**Meeting of the Central Valley Flood Protection Board  
July 27, 2012  
Staff Report – Encroachment Permit  
Sacramento Area Flood Control Agency (SAFCA)  
Unionhouse Creek Improvements, Sacramento County**

Consider approval of Permit No. 18777

The applicant proposes to widen the existing concrete-lined bottom of Unionhouse Creek by 8-feet from Franklin Boulevard to Center Parkway; and to concrete line the side slopes of Unionhouse Creek from Center Parkway to Bruceville Road; and relocate an existing City of Sacramento sump pump (Sump No. 201).

SACRAMENTO AREA FLOOD CONTROL AGENCY  
UNIONHOUSE CREEK CHANNEL IMPROVEMENTS  
EXISTING CONDITIONS  
HYDRAULIC MODEL WORKMAPS  
MAY 2012

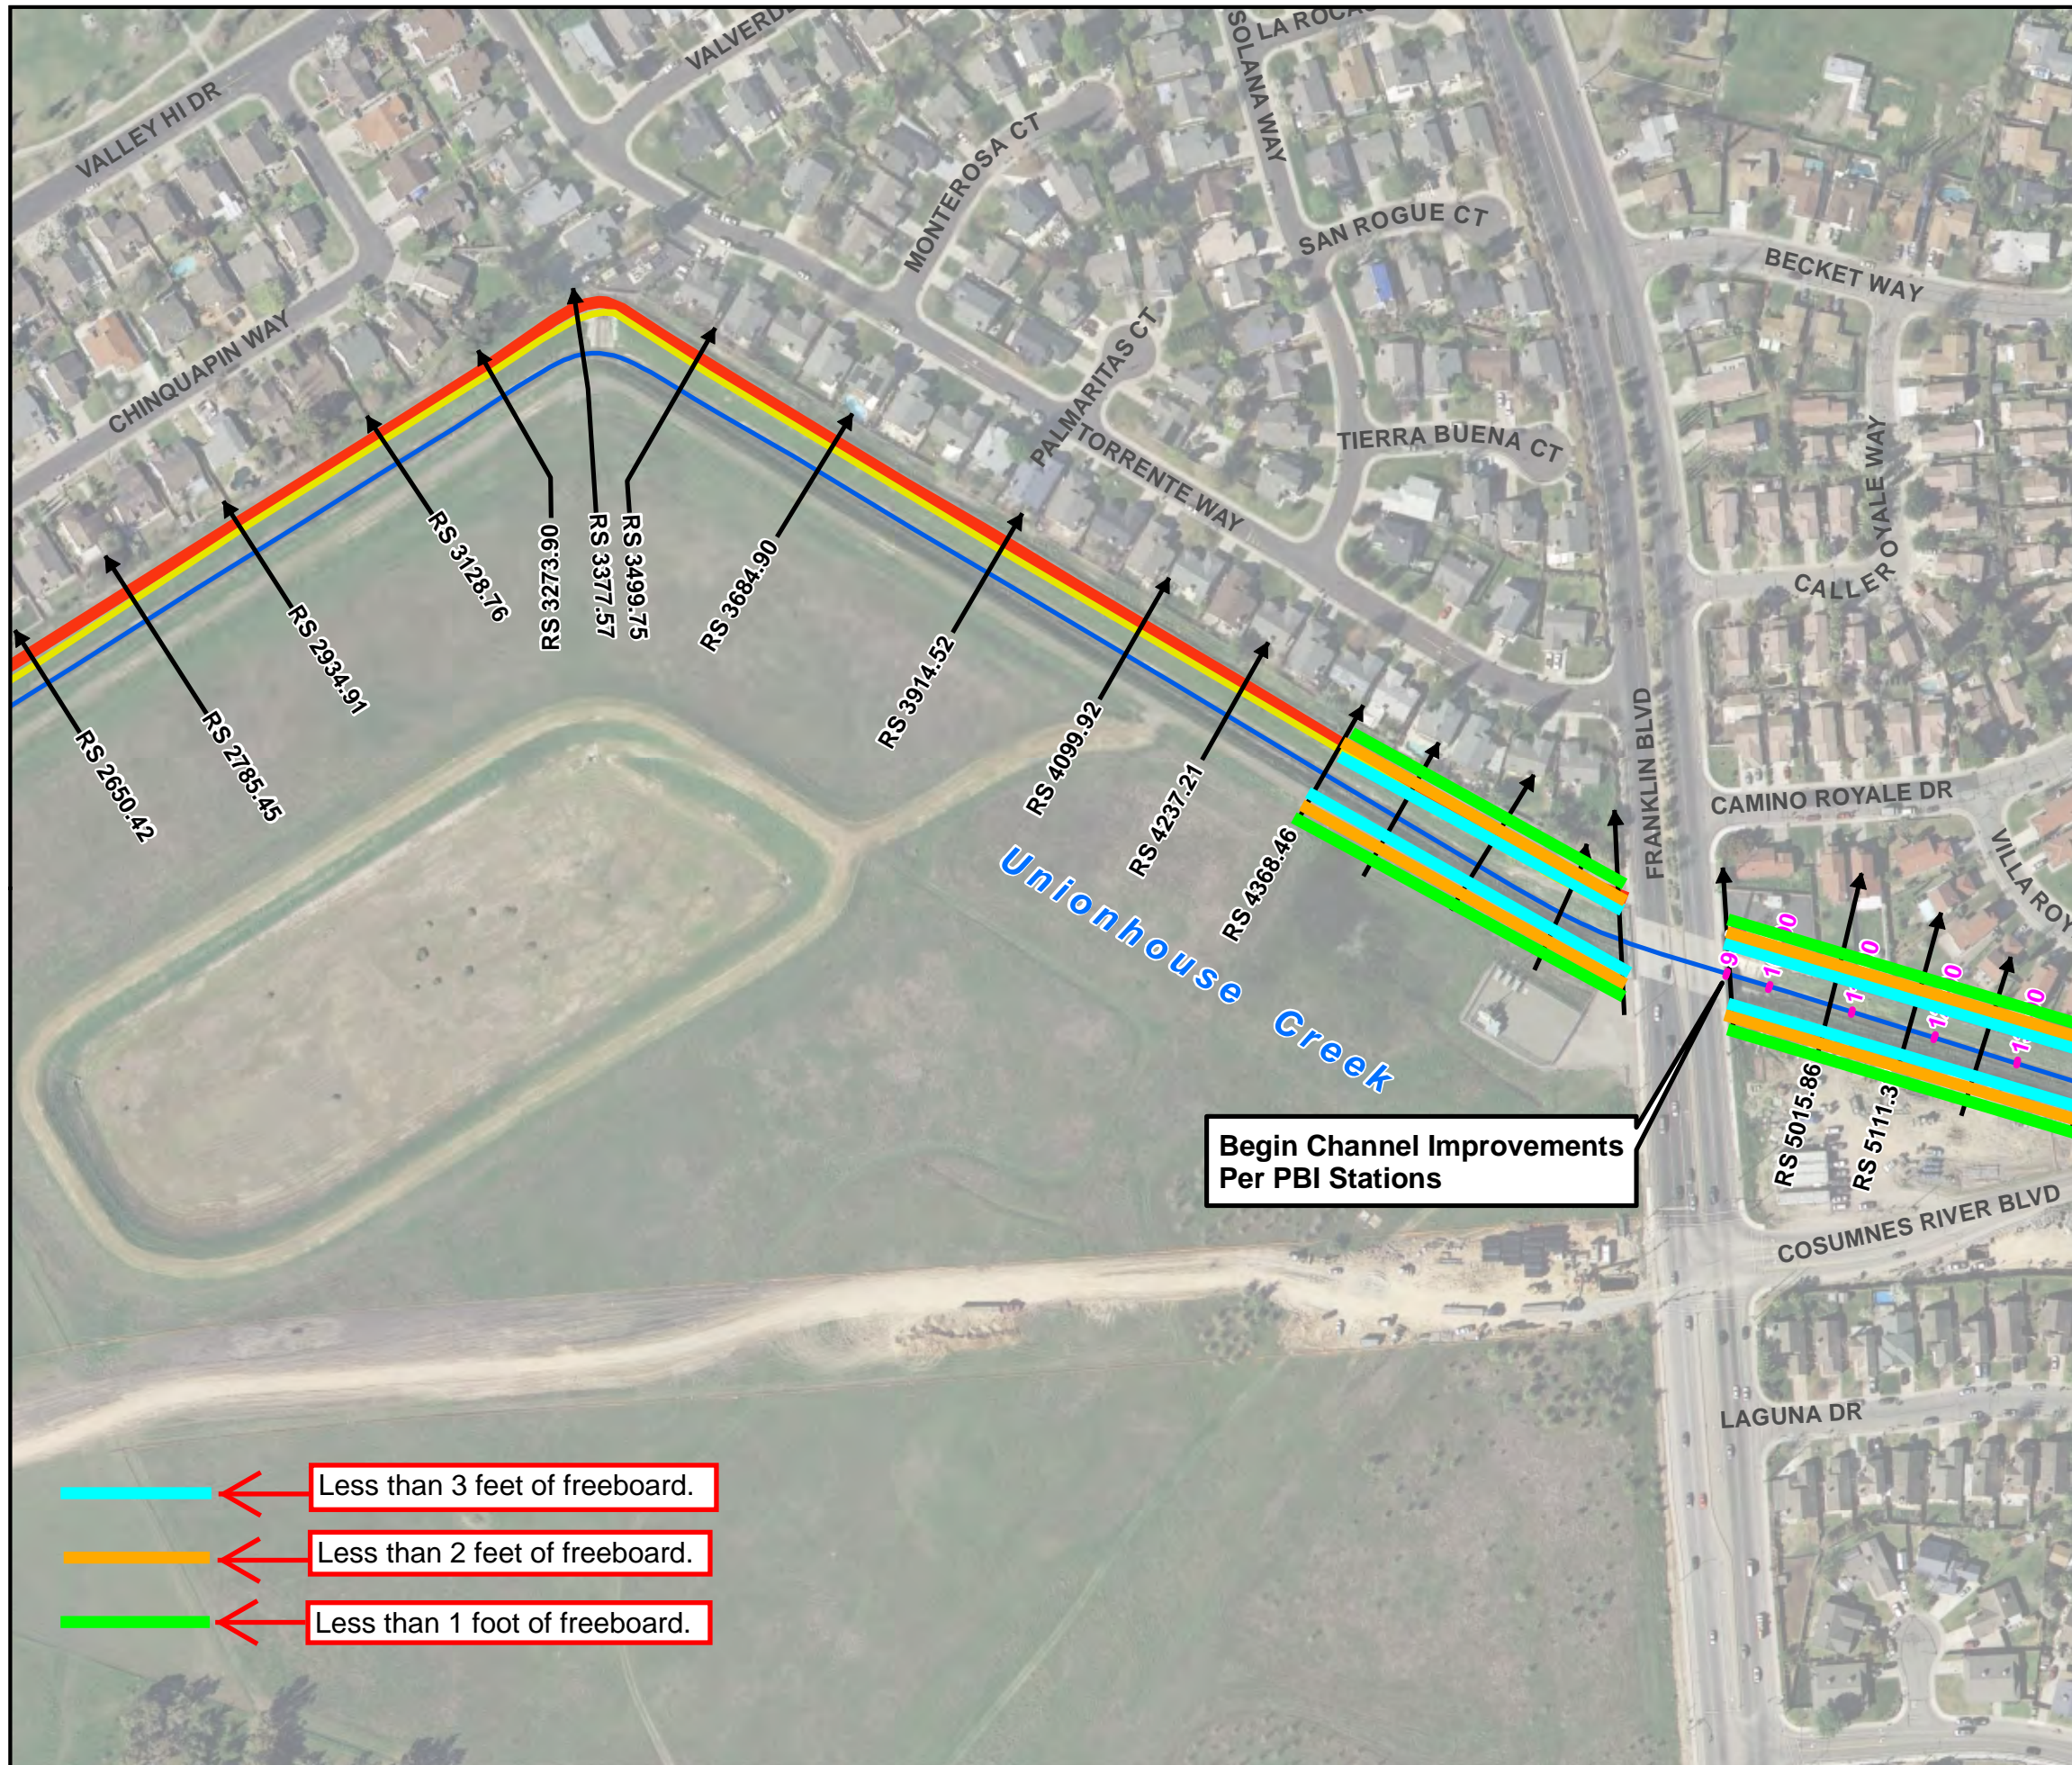
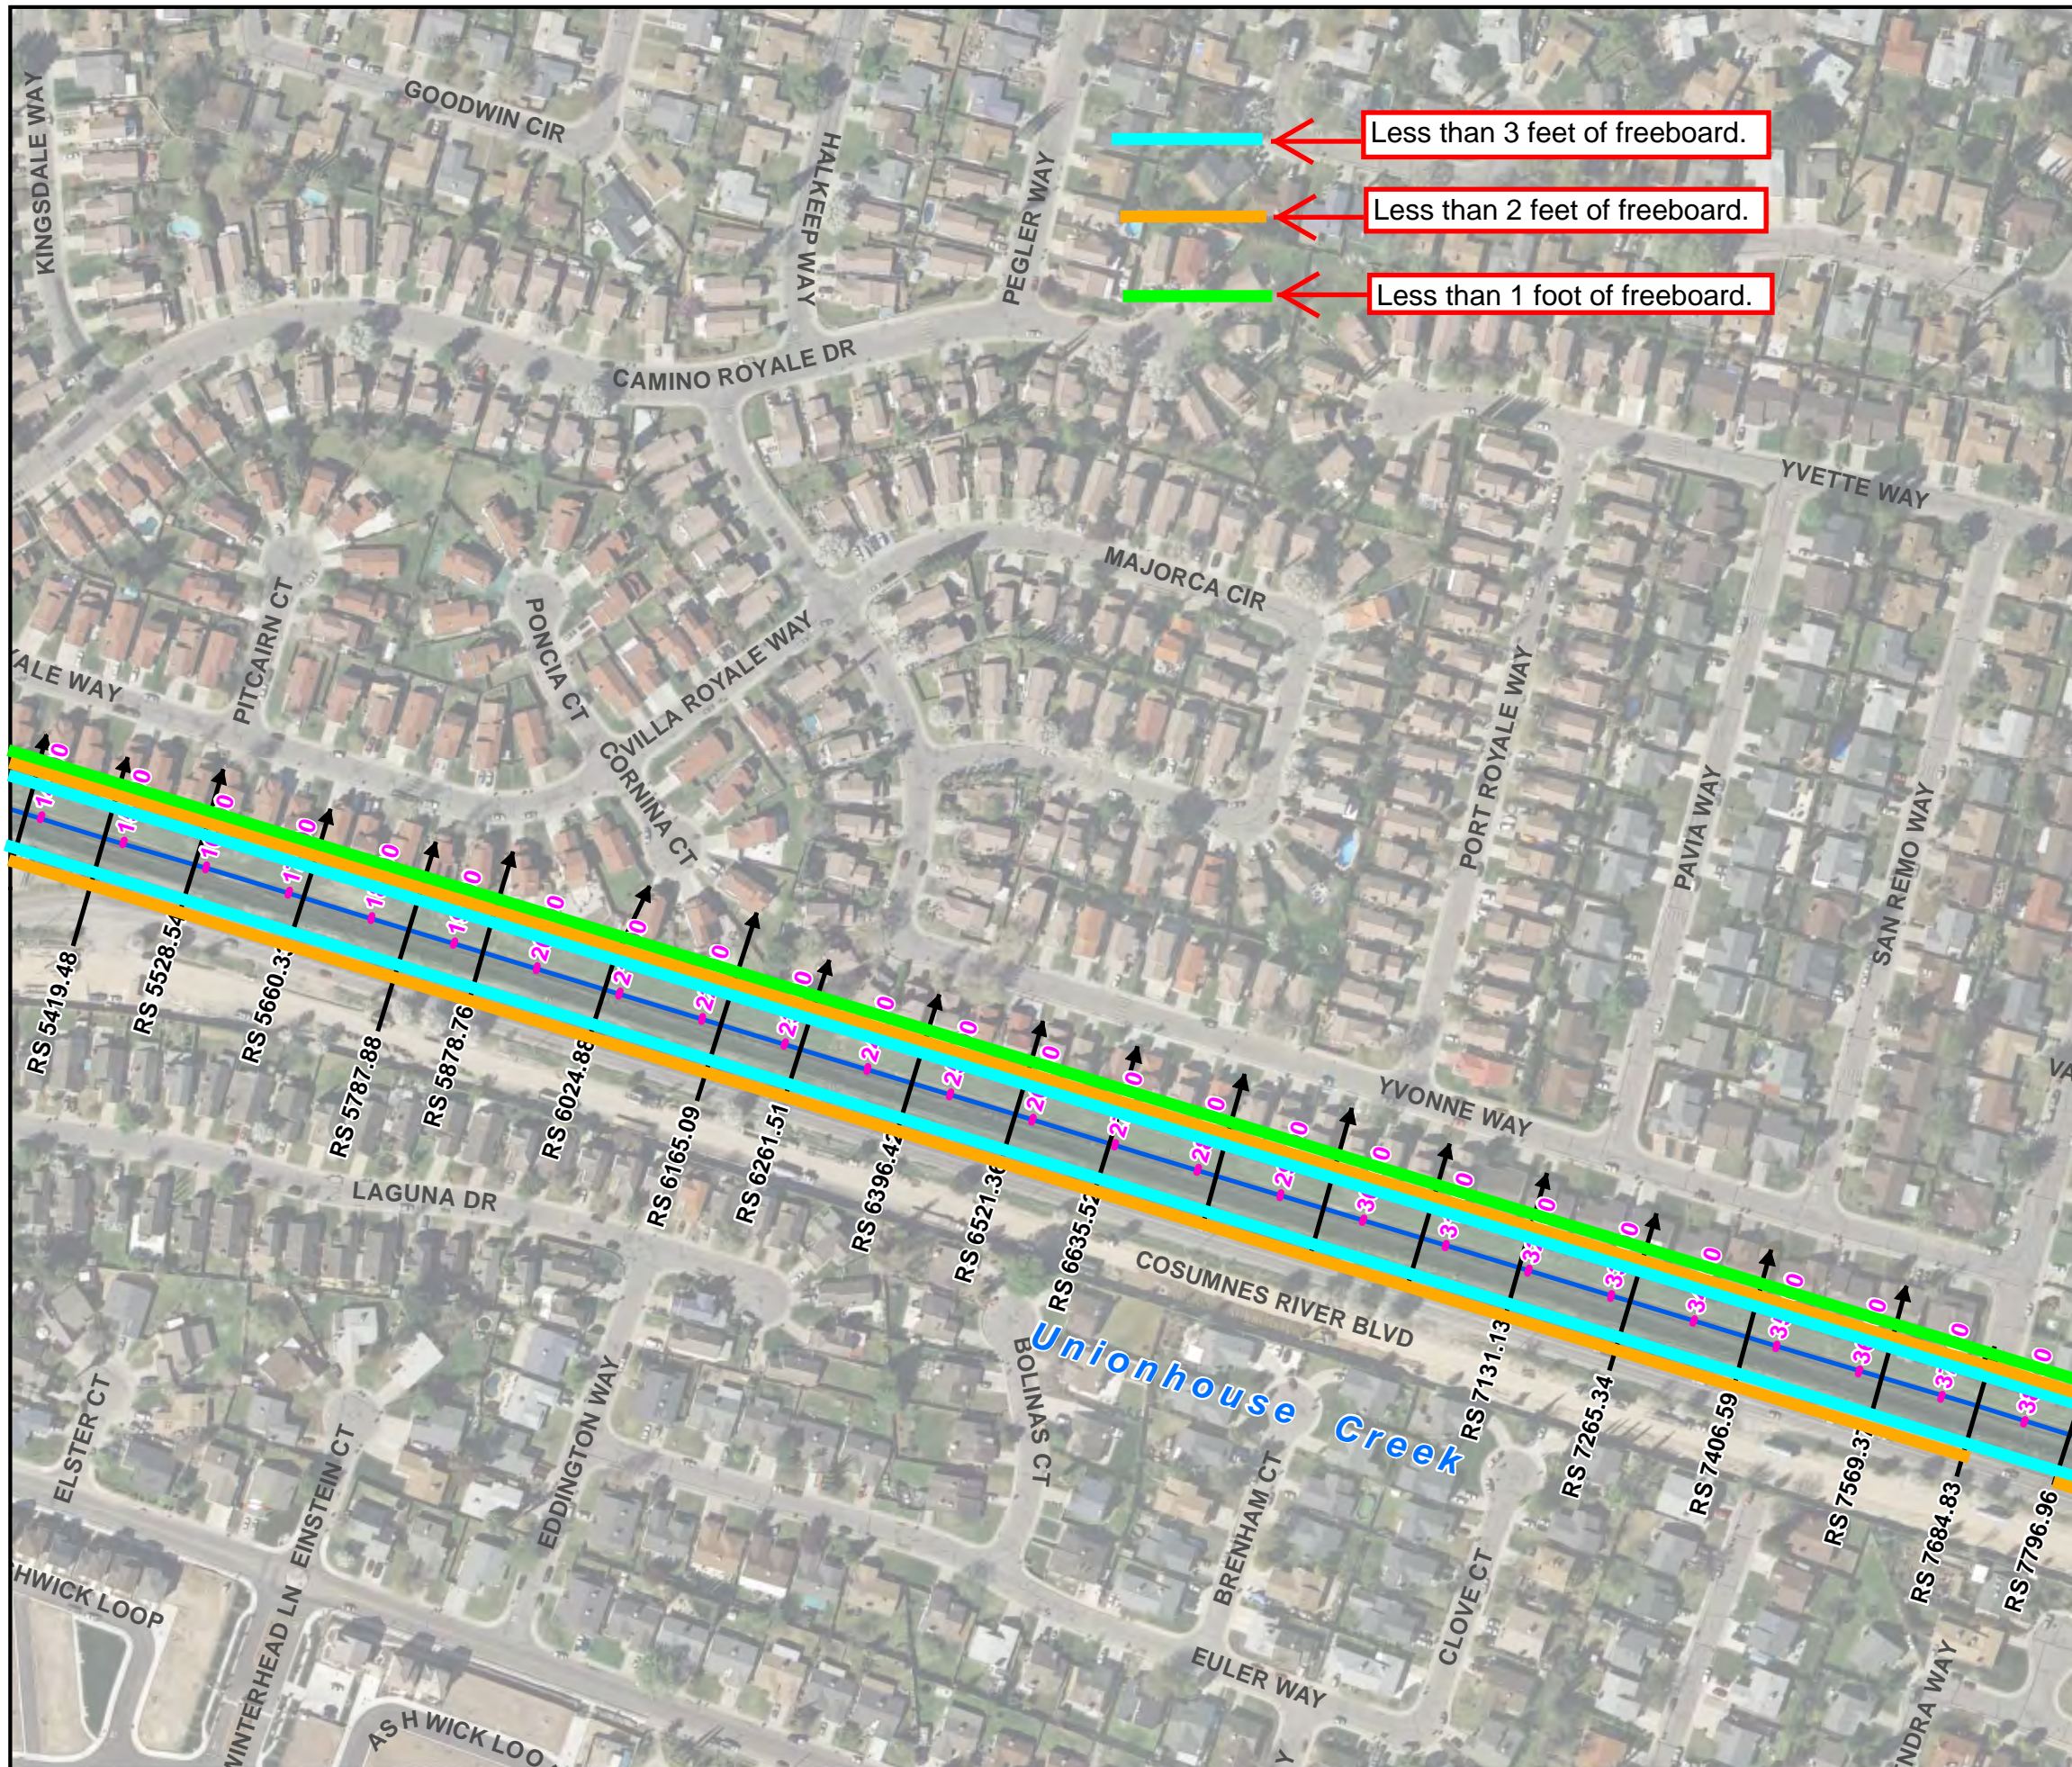
A hydraulic analysis was conducted by Wood Rodgers (WR) in May 2012 to evaluate the design proposed by SAFCA and demonstrate that the 100-year water surface elevation (WSE) would be contained in the new channel conveyance. However, the HEC-RAS model developed by WR did not include any improvements as part of the RT light rail project next to Unionhouse Creek in the analysis. CVFPB staff requested WR to re-run the HEC-RAS model considering the proposed RT light rail improvements and received an updated hydraulic report from WR on July 9, 2012. The results concluded that the proposed RT improvements would elevate the 100-year and 200-year WSE for the existing Unionhouse Creek configuration, noting that with RT's embankment above the 100-year WSE, southerly Unionhouse Creek overland release would no longer flow to Consumnes River Boulevard when additional channel capacity is needed. As a result, both peak flows and WSE's will increase and potentially flow north towards residential development. However, when WR ran the HEC-RAS model including a widened and improved Unionhouse Creek as proposed by SAFCA, the model indicated adequate capacity to contain the 100-year flow, and 200-year flow, with a limited amount freeboard. This limited freeboard is less than 3 feet, 2 feet and 1 foot in many locations, and in some locations it is negative. Attachment C shows the Unionhouse Creek hydraulic profile, cross sections, cross section details, detailed calculated freeboard table, aerial photo graphical freeboard representation and the FEMA 100-year floodplain for this area.

- c. CVFPB staff concludes that a safety factor (i.e.: freeboard) should be incorporated into this project in the near future, because CVFPB staff also concluded that 37% of the proposed project, as currently designed, provides less than 1 foot of freeboard for the adjacent property owners, calculated as follows:
